# Access Compliance Report

### (Curb Ramps)

Intersection ID: 27404	Main Street: BALLANTYNE COMMONS PY	Cross Street: MEADOW RUN LN	Location: SW
ADA ID: BFCBCCDCA071	Ramp Type: Perp	Initial Pass/Fail: Fail	Overall Compliance: No
Severity Score: 8.75			
Codes/Mitigation Info/Possible Solution		Field Measurements/Component Compliance

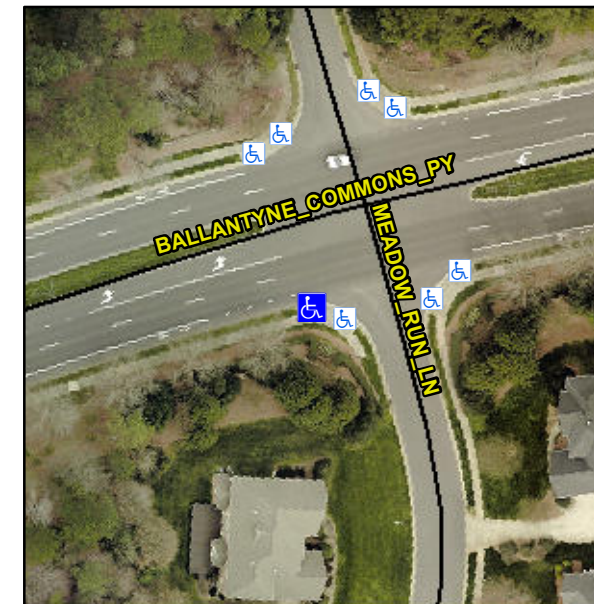
**Not Found, R304.5.1**

Compliance	Description	Data	Compliance	Description	Data
N/A	Ramp Length (in)	107.0	Yes	Ramp Slope (%)	6.5
No	Ramp Width (in)	42.0	Yes	Ramp XSlope (%)	1.7
N/A	Flare Type LT	N/A	N/A	Flare Type RT	N/A
N/A	Flare Slope LT (%)	N/A	N/A	Flare Slope RT (%)	N/A
N/A	Flare Traversable LT?	N/A	N/A	Flare Traversable RT?	N/A
N/A	Landing Length (in)	N/A	N/A	DWS Provided?	N/A
N/A	Landing Width (in)	N/A	N/A	DWS Contrast?	N/A
N/A	Landing Slope (%)	N/A	N/A	DWS Length (in)	N/A
N/A	Landing X Slope (%)	N/A	N/A	DWS Full Width?	N/A
N/A	Landing Curb? (Y/N)	N/A	N/A	DWS Offset (in)	N/A
N/A	Shared Landing?	N/A			
N/A	Gutter Ponding?	N/A	N/A	Gutter Slope (%)	N/A
N/A	Gutter Lip Ht (in)	N/A	N/A	Gutter X Slope (%)	N/A
N/A	Painted X Walk1?	No	N/A	Painted X Walk2?	N/A
	X Walk 1 Direction	To N		X Walk 2 Direction	N/A
N/A	X Walk 1 Width (in)	N/A	N/A	X Walk 2 Width (in)	N/A
	X Walk 1 Slope (%)	3.6		X Walk 2 Slope (%)	N/A
	X Walk 1 X Slope (%)	0.7		X Walk 2 X Slope (%)	N/A

**Remove & Replace Entire Ramp.**
